Construction Drawings for Meridian Rd./Bent Grass Meadows Dr. Intersection Improvements

Bent Grass Metro District, County of El Paso, State of Colorado

Conditions (part 2) -- Per letter dated 9/22/2020, Developer and Developer's engineer agree to evaluate the revisions below and provide revisions as acceptable to the County Engineer.

TRAFFIC CONTROL
SIGNAL PLANS
Bent Grass Meadows Dr./Meridian Rd.

STREET NAME SIGNS

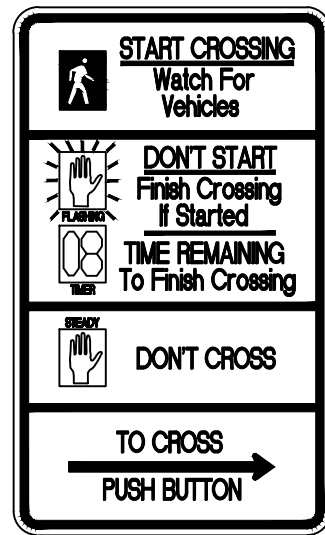
- H. Signs and Striping note 7 - 24" Blanks with 12" Upper Case letters for our D3 signs at signals in "D" Series letters.
- I. Signs and Striping note 9 - All roadway signs need to be on slip base post, not square tube, because of the design speed.

- j. Ensure that overhead street name signs follow MUTCD Table 2D-2 design (24" tall, 12" and 9" lettering).
